ADDENDUM # 2

**RFQ# 7461369
Title: REPLACEMENT OF GENERATORS LINCOLN CAMPUS, CCRI
Submission deadline: MAY 1, 2013 AT 11:30 AM (Local Prevailing Time)**

RFQ # 7461369
CCRI LINCOLN GENERATOR REPLACEMENT
ADDITIONAL SCOPE OF WORK

DIAGRAM 7 (a)

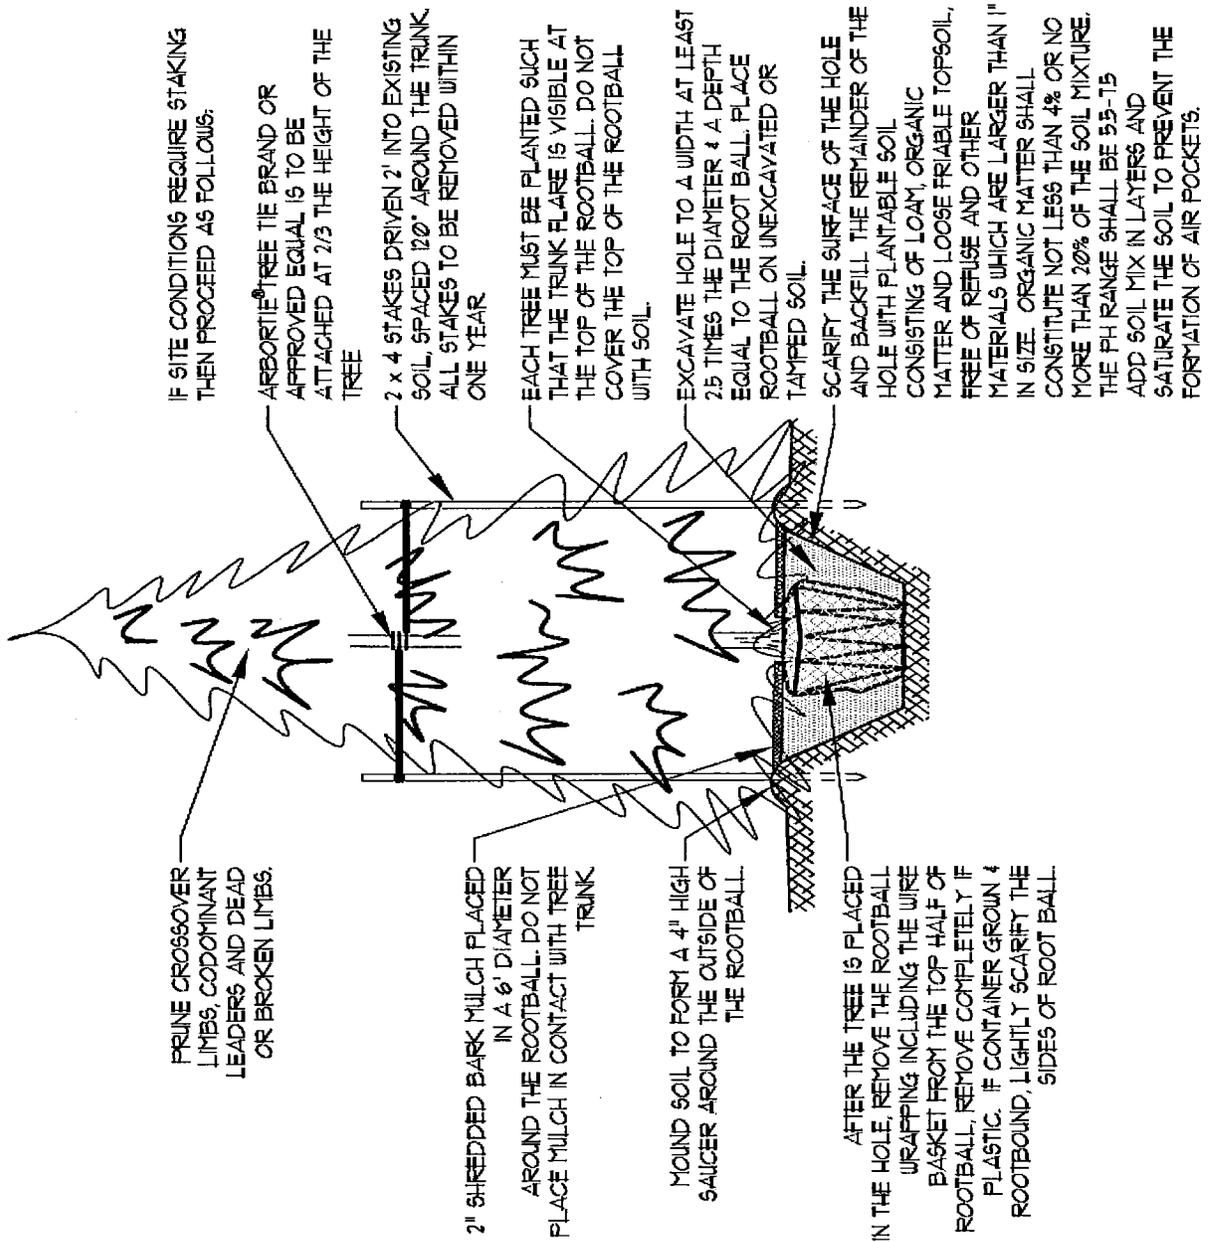
7. Provide forty (40) 6'- 8' high large emerald green arborvitaes on front and side of Mod 1 as well the fenced MOD 2/3 generators. Planting shall be a minimum of 4' from face of generator or fence. Plantings shall comply with the following:
 - a. Planting shall follow the detail specifications in attached DIAGRAM 7(a)
 - b. Planting season shall be no later than October 1st and no earlier than May 1st.
 - c. Plantings to include bed application of three (3") inches of pine mulch.
 - d. All plantings will be guaranteed for a period of one (1) year from the date of substantial completion.
